City of San Diego
Development
Services
Department

Environmental Impact Report

LDR No. 96-0165
SCH No. 96031091

SUBJECT: New Century Center. GENERAL PLAN AMENDMENT (GPA), COMMUNITY PLAN AMENDMENT (CPA), REZONE (RZ), VESTING TENTATIVE MAP (VTM), PLANNED COMMERCIAL DEVELOPMENT (PCD), PLANNED INDUSTRIAL DEVELOPMENT (PID) and RESOURCE PROTECTION ORDINANCE (RPO) PERMIT to amend the existing general plan and Kearny Mesa community plan. The property would be rezoned from M-1A and M-1B to M-1A M-1B, CA and OS-TDR. A VTM, PCD, PID and RPO Permit would allow redevelopment of the General Dynamics Kearny Mesa site with a mixture of retail/entertainment, commercial and industrial uses, an 8.5-acre Missile Park and a 4.3-acre vernal pool conservation bank. The 243.7-acre property is located at 5001 Kearny Villa Road, between Clairemont Mesa Boulevard and Balboa Avenue, in the Kearny Mesa community (Lots 4, 5, 6, 11, 12, 13 and Portion of Lots 20, 21 and 22 of the Highlands, Map No. 284; Portion of Blocks 1, 2, 9 and 10 of Rosedale, Map No. 826). Applicant: General Dynamics.

VESTING TENTATIVE MAP FOR
NEW CENTURY CENTER
TM 98-0165

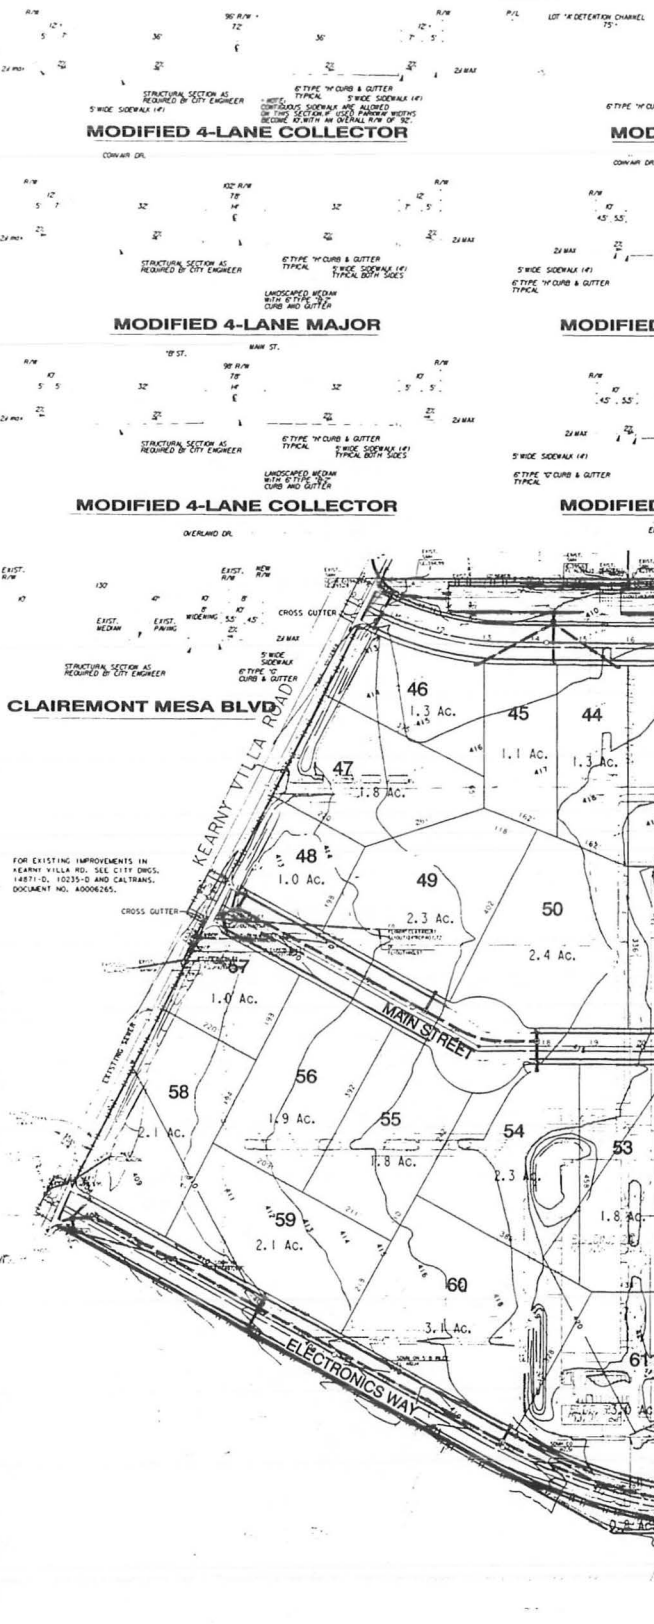
Subsequent to public review, the applicant revised the proposed Vesting Tentative Map (VTM) to include grading. Grading on approximately 222 acres of the site would occur. Grading

activities would result in approximately 450,000 - 500,000 cubic yards of balanced cut and fill on-site. The Final Program Environmental Impact Report and VTM (Figure 3-4) have been revised accordingly.
